Knoxville Historic Zoning Commission

File Number: 8-E-24-HZ

Level II Construction of Addition or Outbuilding

ITEM 2 SUNROOM

AS-BUILT CONSTRUCTION OF SUNROOM BASED ON 1998 RENOVATIONS

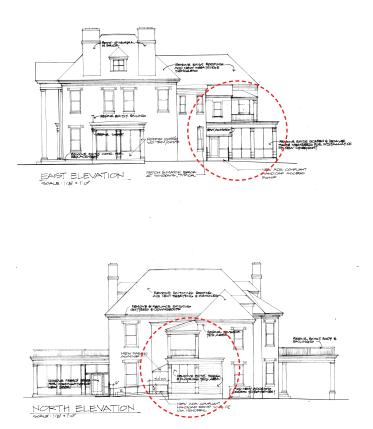
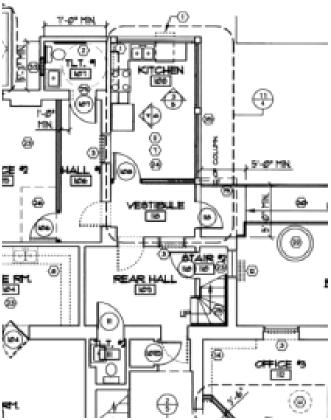
3. The sunroom underwent rehabilitation in the late 1990s to receive new storefront windows, new siding, and new flooring. The age of the existing columns and wood trim is not known. The curved trim on the previous (now removed) design aligned with the house's Victorian era.

This is an update to the 6-B-22-HZ COA approved application which set us to work on the Sun Room/former porch. Upon starting work on the sunroom from our initial approval it was found that what was existing had no usable foundation and all its wooden parts were either found to be a contemporary 1998 era renovation or had simply rotted out leaving no structure to repair in place.

5. The new sunroom will be differentiated from the original house via a new design with clearly new materials, including new French doors, transoms, and sidelights in a simple pattern not visible on the original house. The sunroom could be removed without effect on the primary house.

Staff recommends approval of Certificate 8-E-24-HZ as submitted.
